307-12-04
July 11, 2013

Re: CEMEX South Cement Plant Alternative Fuel/Material Processing Facility
Pending Permit #22787-004-SO/31
WACS: 40778, Brooksville, Hernando County, Florida

On behalf of CEMEX Construction Materials Florida, LLC (CEMEX) Koogler and Associates, Inc. (Koogler) is responding to the Department's request for additional information (RAI) dated April 24, 2013. The RAI items and our responses are as follows:

Figure 1 - Site Plan
AFM Storage/Processing Locations
CEMEX Brooksville South-Alternative Fuel Material
Permit Application, 62-701, FAC
Brooksville, Hernando County, FL

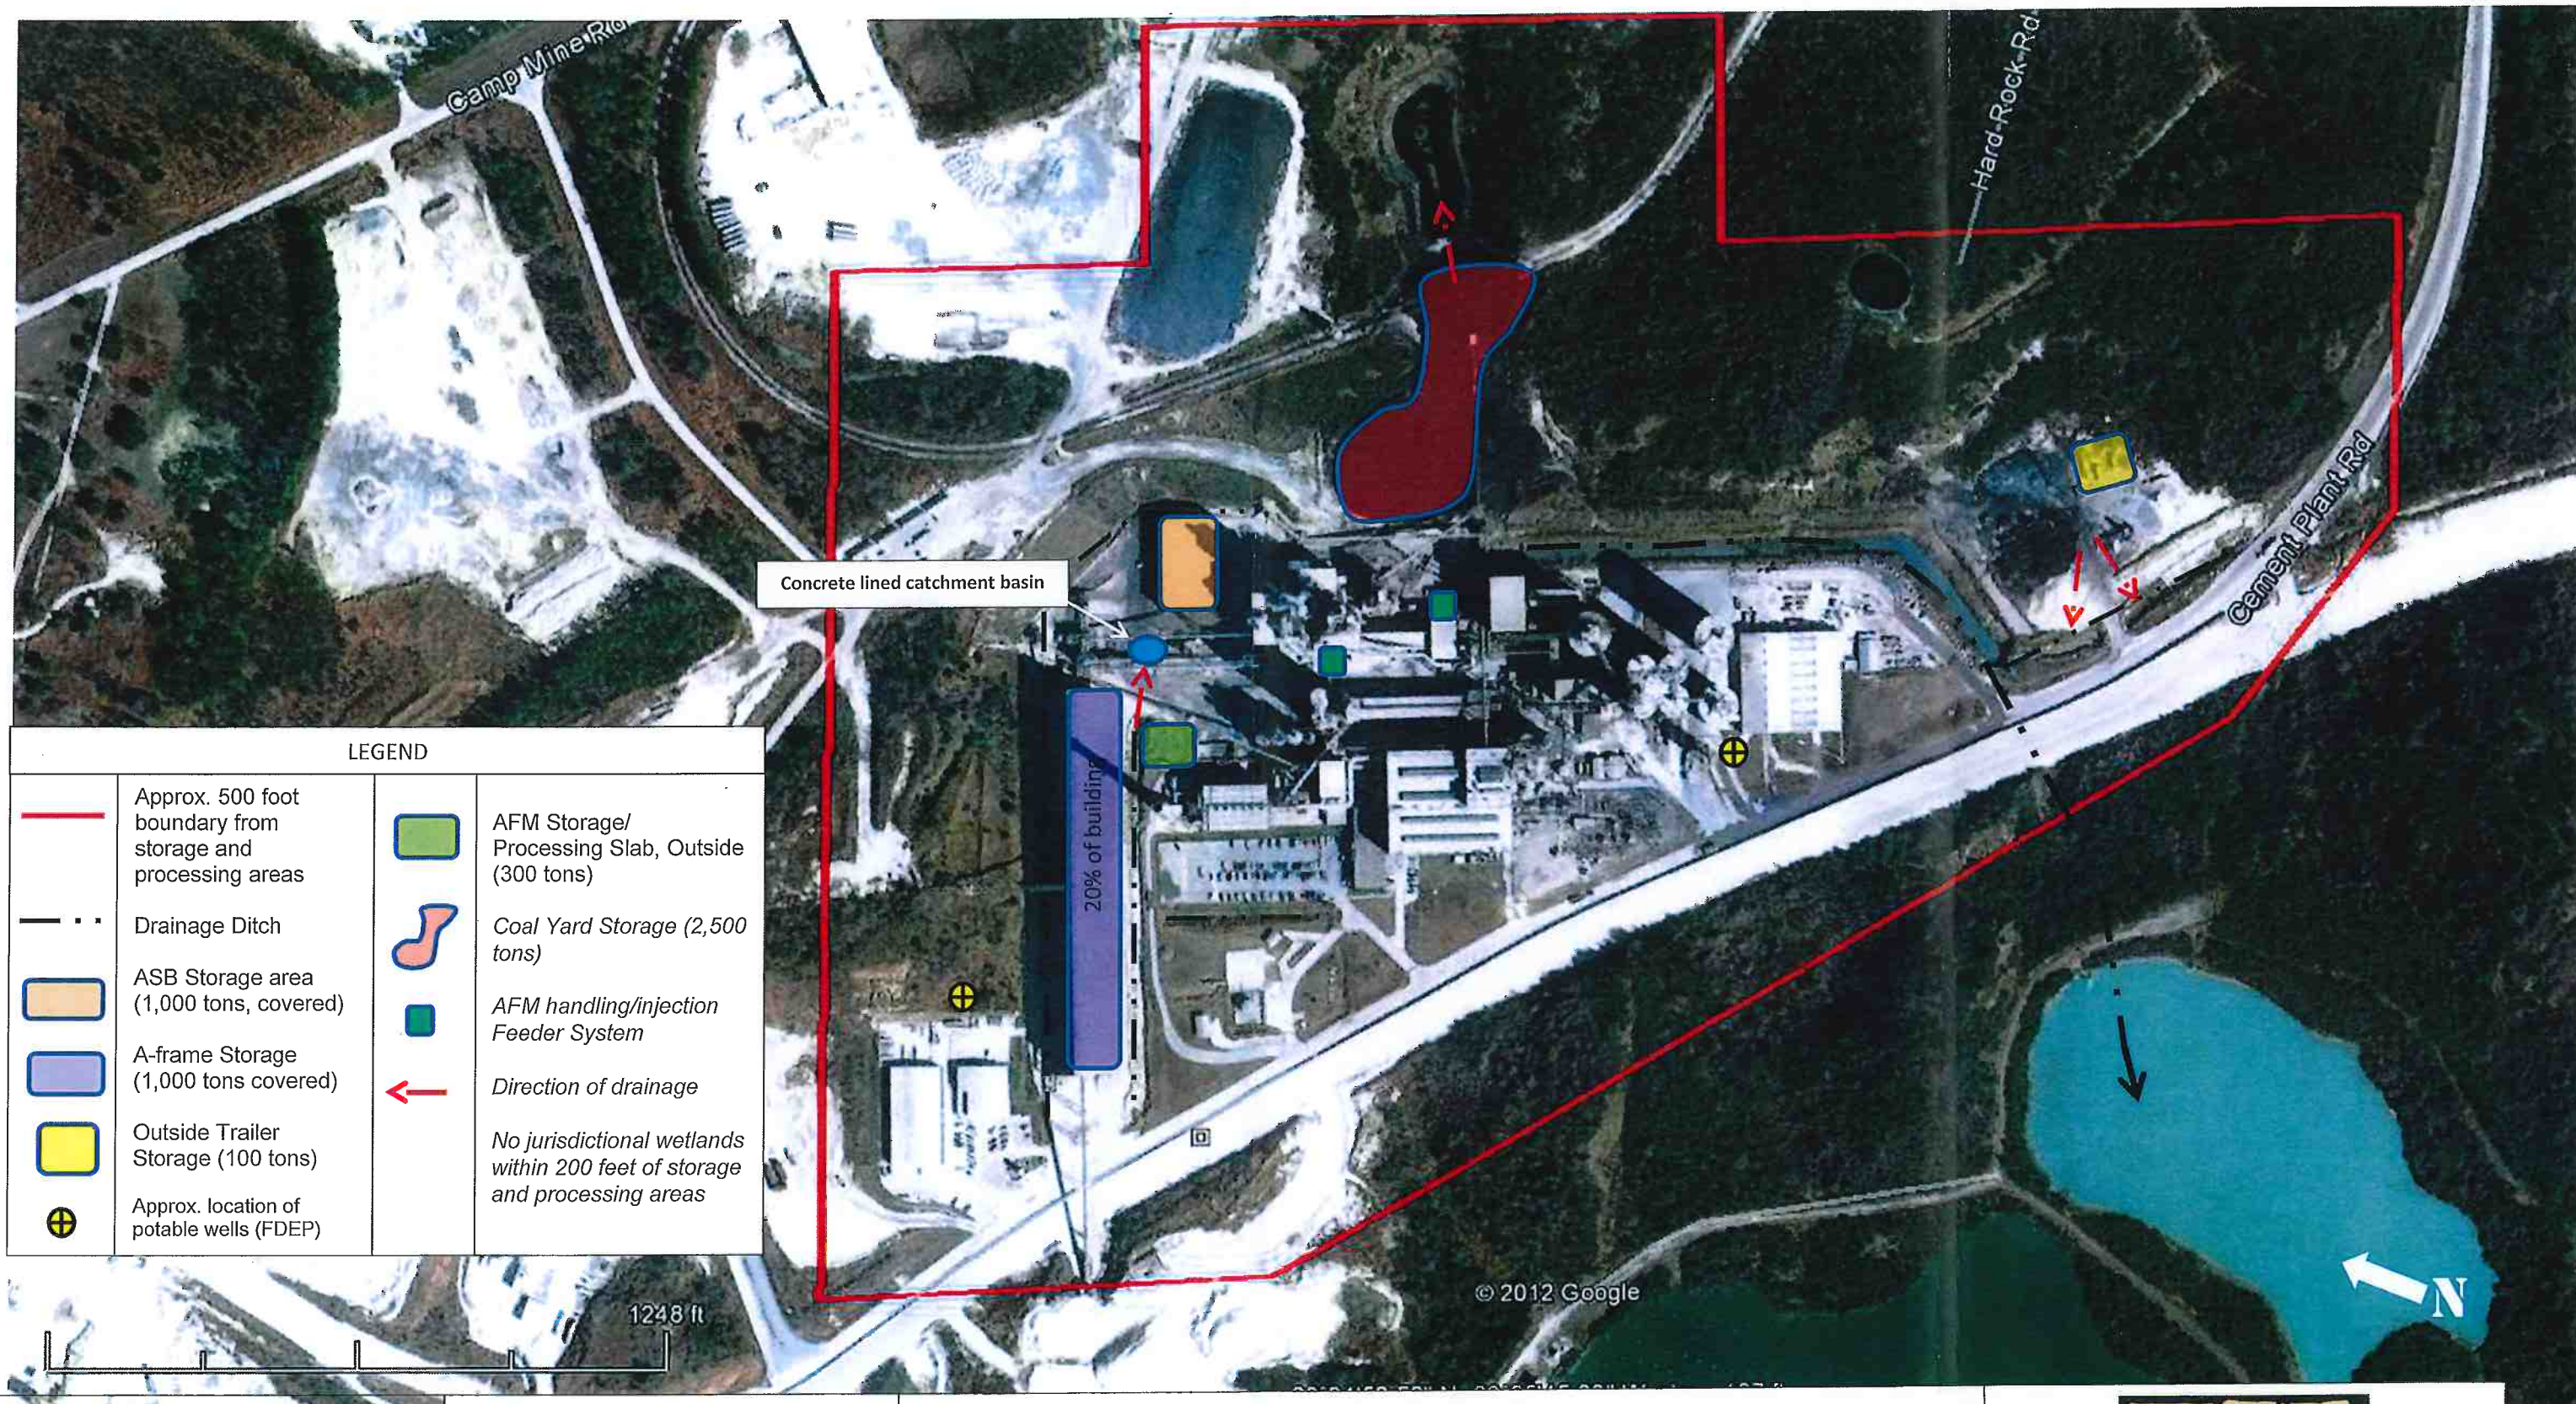
Additionally, the drainage ditch on the south side of the A-Frame building directs run-off to a concrete lined collection basin. The basin then drains through an underground pipe to the perimeter ditch and is pumped to the stormwater pond across Cement Plant Road. The remaining ditches also discharge through culverts into the large perimeter ditch. See revised Figure 1 in the "Engineering Report" for the direction of drainage.
